**ADDENDUM NO. 1**

December 10, 2020

**THE CITY OF GREENVILLE NC  
FIRE RESCUE NO. 1 BAY EXPANSION  
500 S GREENE ST, GREENVILLE, NC 27834  
ARCHITECTS PROJECT NO. 1667**

Sheet No. 4.11

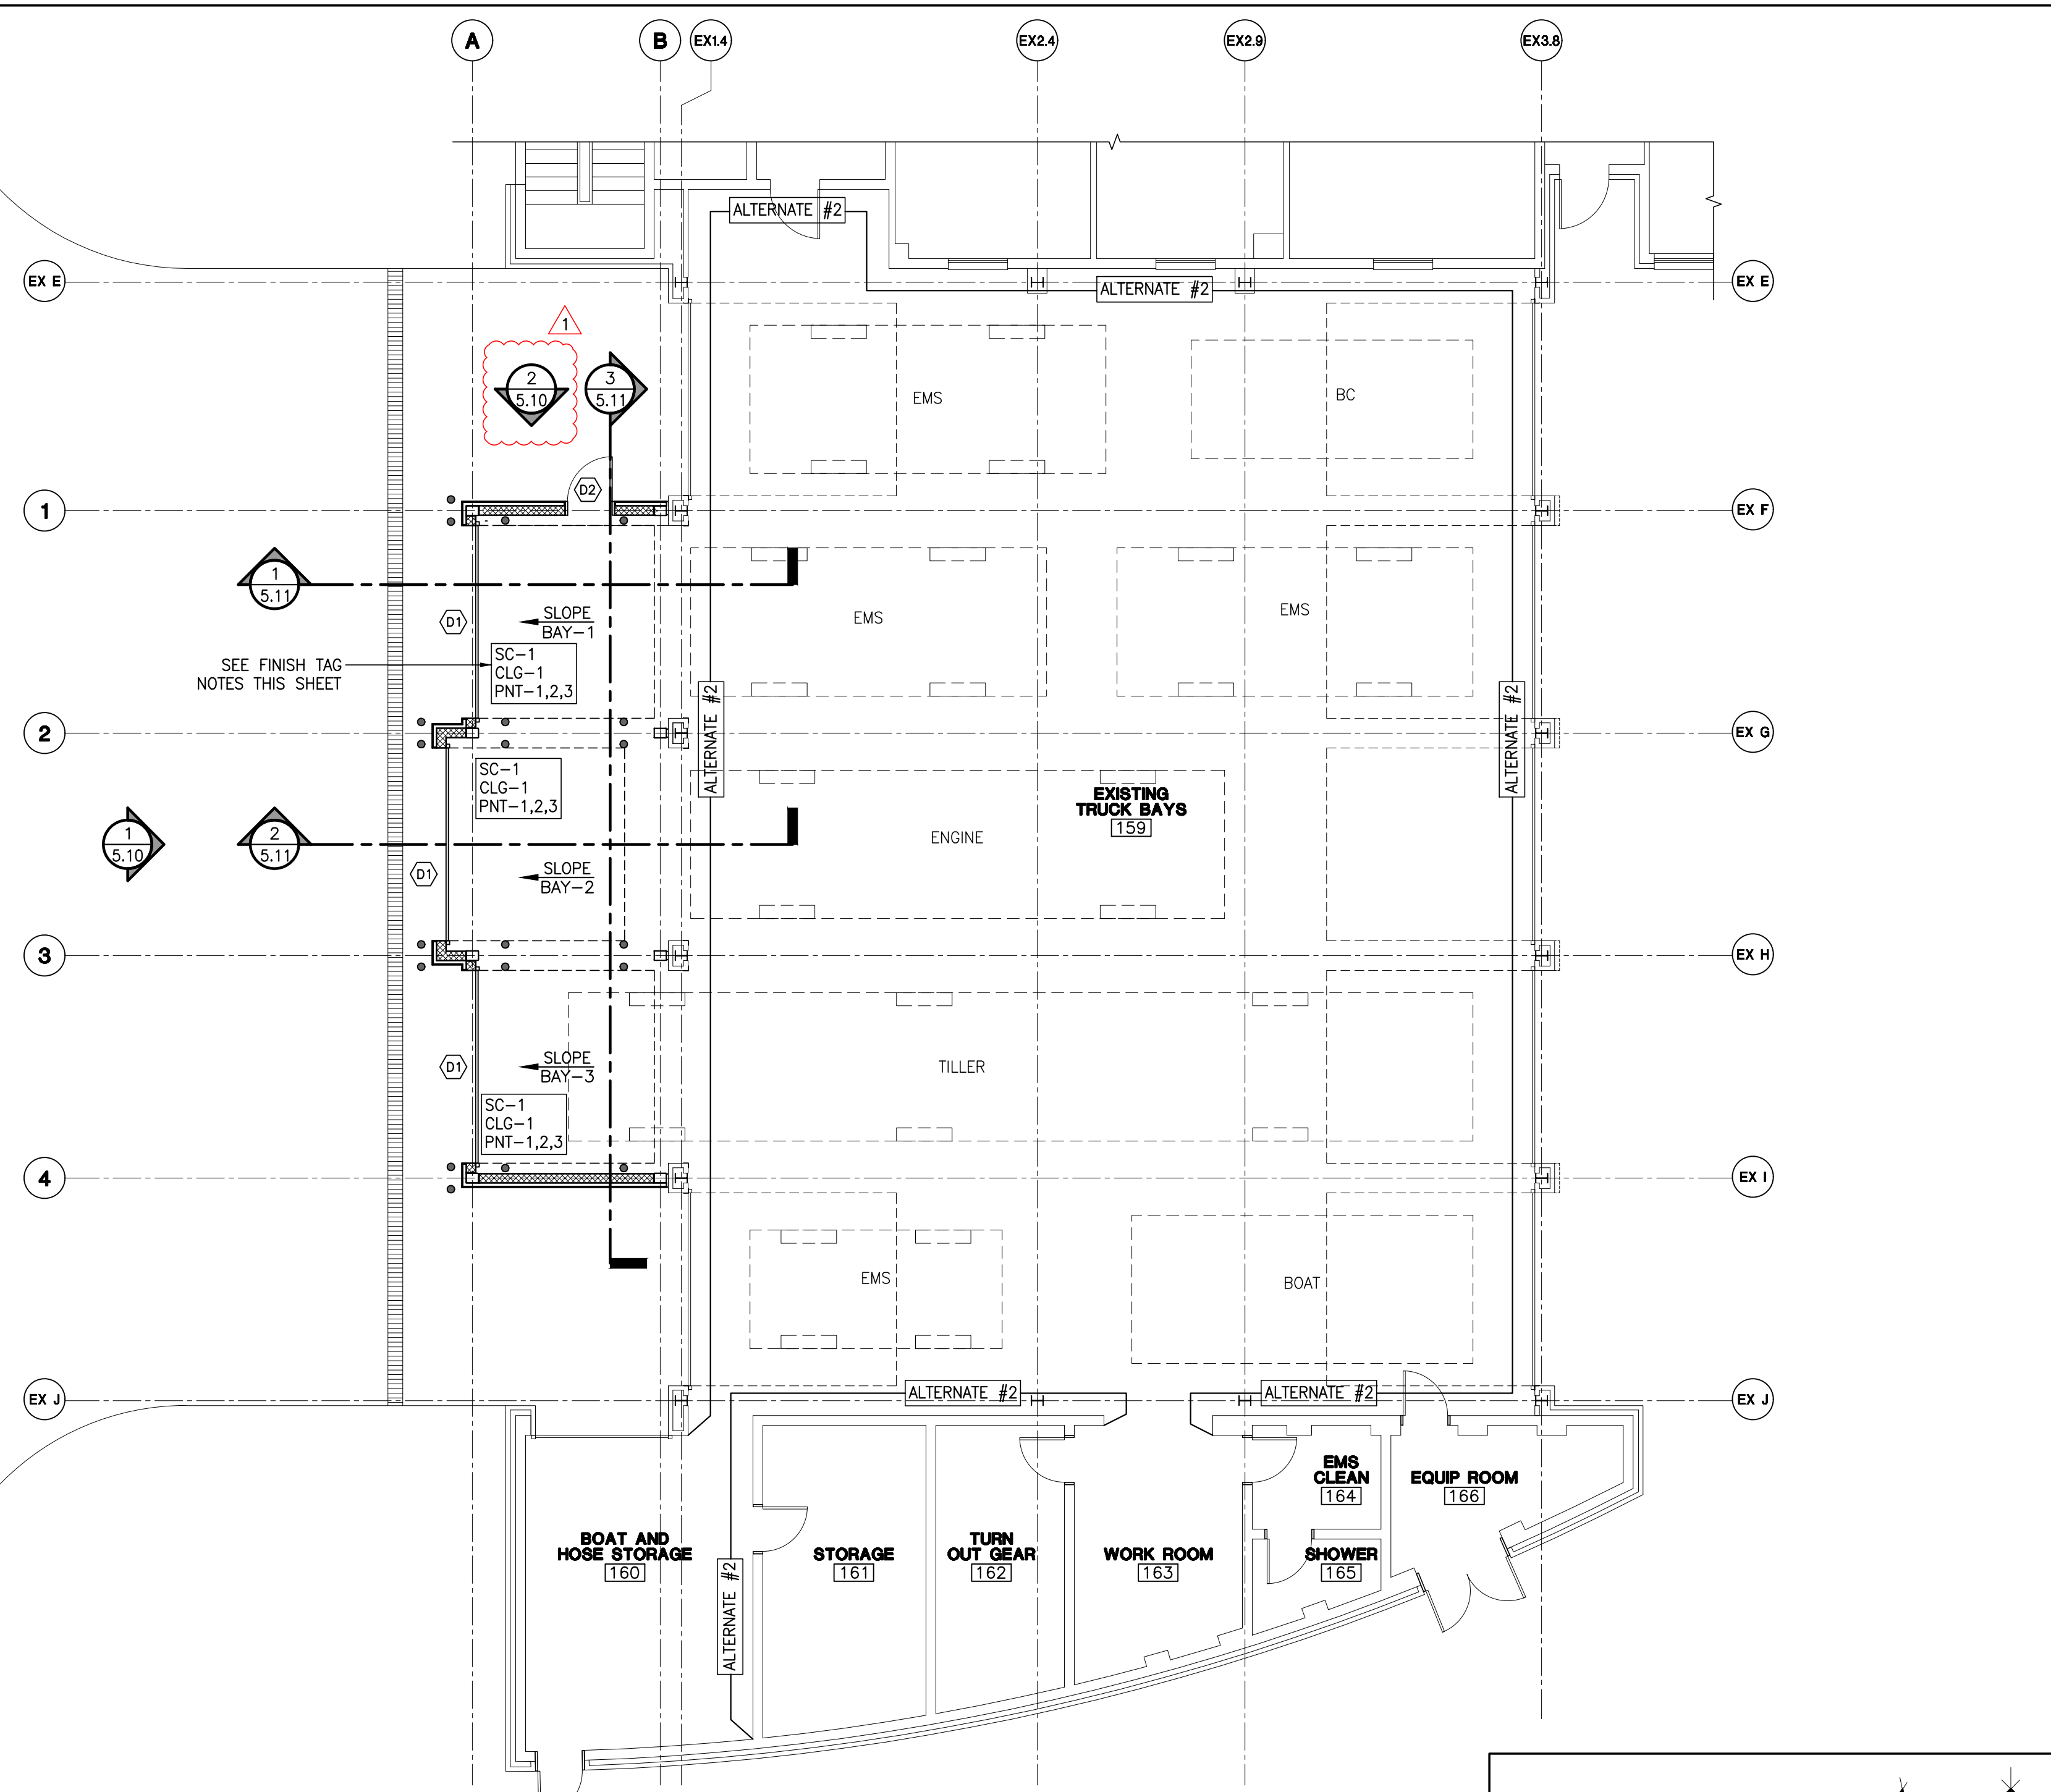
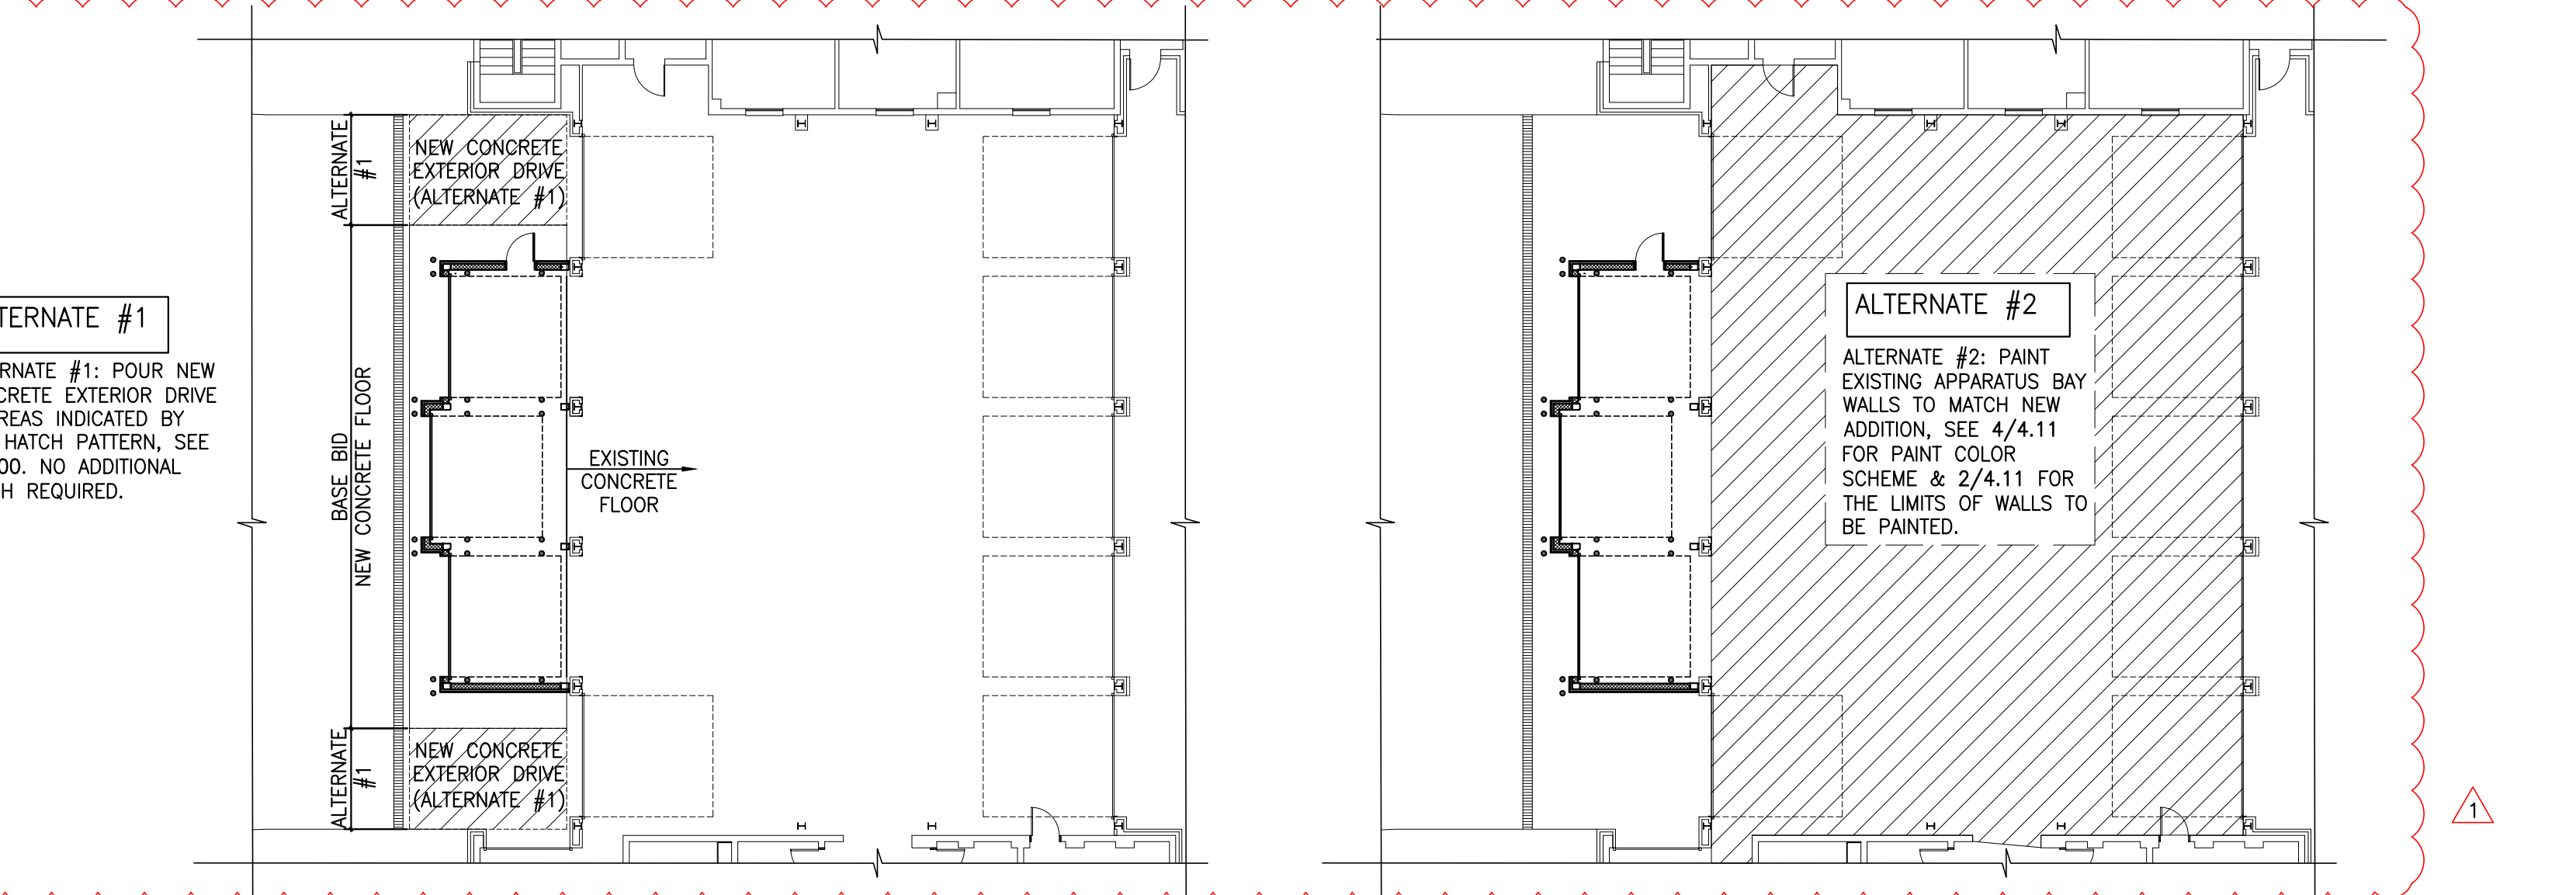
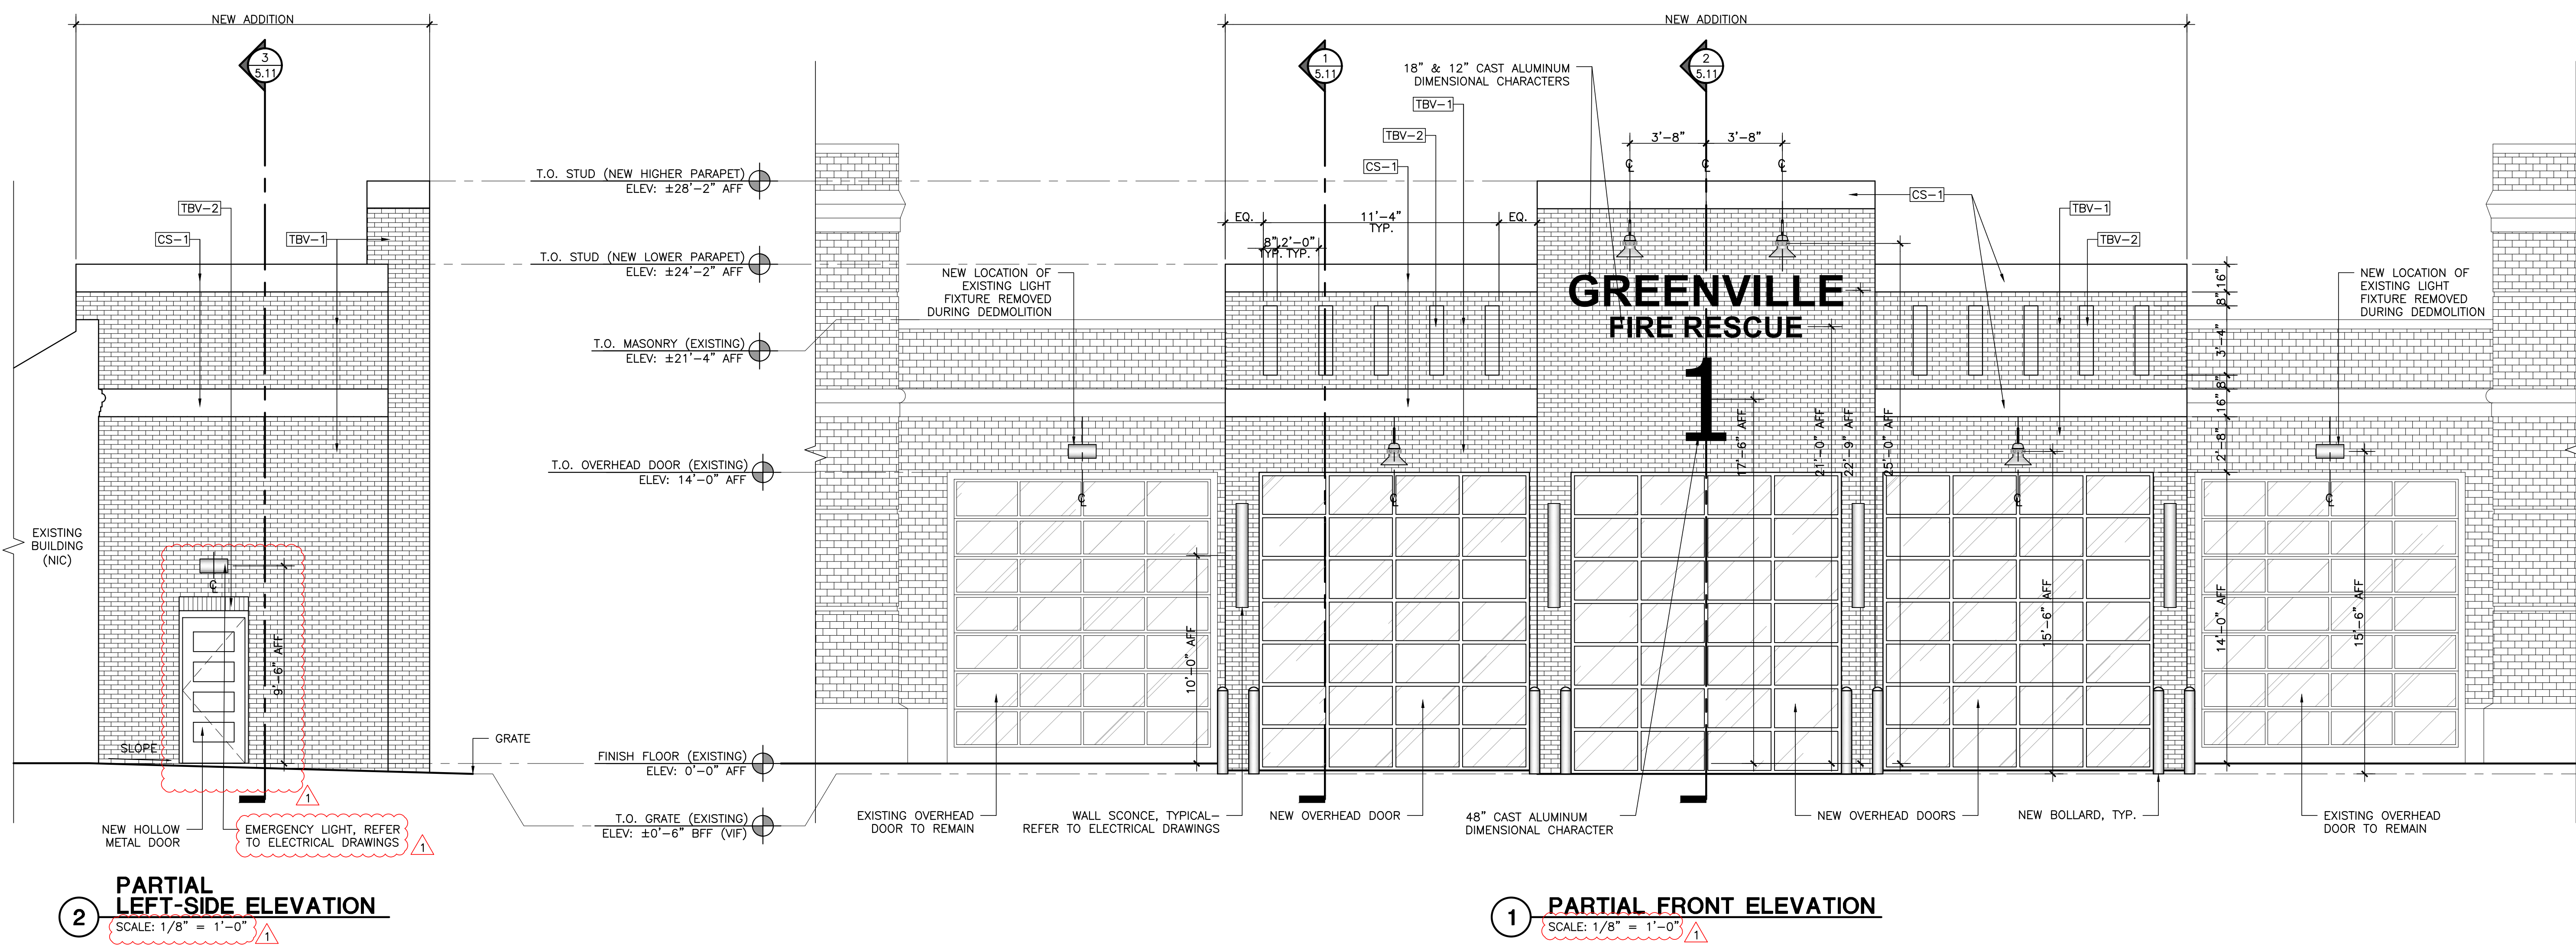
- 4.11** See clouded items on revised drawing which includes changes to: Detail 1/4.11 - Door Type D2, HM Door Specs, Hardware, Detail 2/4.11 - Elevation tag location & Detail 3/4.11 - Finish Plan Alternates (see attached revised sheet 4.11 and replace the previous sheet).
- 4.12** Detail 2/4.12 - Closure strips shall be removed and Add under Wood Blocking General Notes: CANTS TO BE SIZED TO AVOID STANDING WATER (see attached **ABD-3**).
- 4.12** Detail 5/4.12, Revised Roof Detail at Transition (see attached **ABD-4**).
- 5.10** Corrected Drawing Scales & Elevation Tag and added new Emergency Light (see attached revised sheet 5.10 and replace the previous sheet).
- 5.11** Detail 1/5.11 & 2/5.11, Bollard detail callout shall be **9/5.21** (see attached **ABD-5**).
